Re: Ordinance 50-13 - Rezoning approximately 12.05 acres located on the east side of existing Drake Road right-of-way (to be vacated), approximately 200 feet south of the intersection with Springburn Drive from R, Rural District to PUD, Planned Unit Development District (Stansbury at Muirfield Village PUD) to establish an 18-Lot single-family detached residential development and approximately 4.5 acres of open space (Case 13-009Z/PDP/PP)

Summary

- 1. Stansbury at Muirfield Village** **10799 Drake Road**
13-009Z/PDP/PP **Rezoning/Preliminary Development Plan**
Preliminary Plat

Proposed Preliminary Development Plan

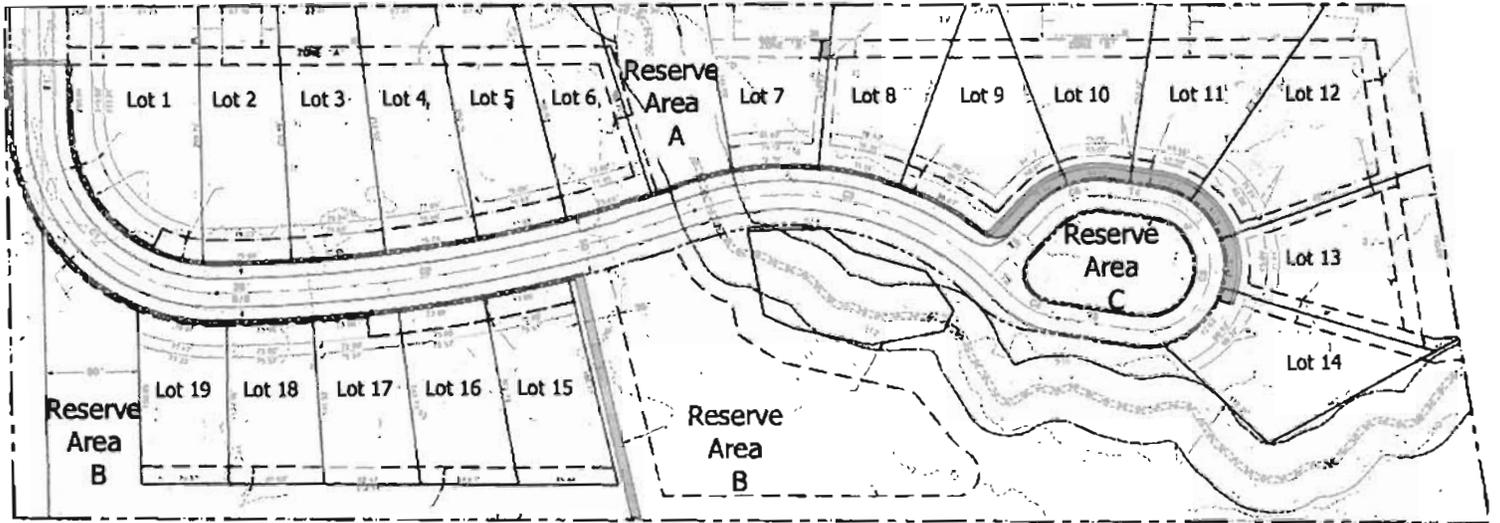
Ms. Amorose Groomes said she agreed that Lot 6 was entirely too tight, and it encroached on the Stream Corridor. She said that 10 feet could be added to Lots 2 through 5, and the balance could be added to the stream corridor.

Ms. Amorose Groomes said she hoped that the pond shape indicated on the drawings was just to indicate the area on which a pond will be located. She said it should look far more natural, free flowing, and more appropriate than having an 85-degree angle as shown. She said at the final development plan stage, she

Ms. Kramb said she was not in favor of adding more sidewalk there because that end has many trees. She said when this plan is rearranged for the final development plan she did not want to see a point in the sidewalk at Lot 9, but a more curvilinear transition which was more practical. She reiterated that she was not in favor of adding more sidewalk, especially were the trees were located.

- Lot 6 be removed from the plat to prevent stream corridor encroachment.
- Provide additional width for Lots 2-5.

- 1) That the applicant ensures that any minor technical adjustments to the plat should be made prior to City Council submittal, including noting the open space ownership and maintenance responsibilities and setback information;
- 2) That the applicant works with Delaware County to identify and follow the required vacation process as part of the Council review of this preliminary plat;
- 3) That the preliminary plat be revised to match the preliminary development plan in terms of the elimination of Lot 6 and the width of Lots 1 through 5; and
- 4) That the sidewalk along Lot 9 be redesigned to a more curvilinear pattern.
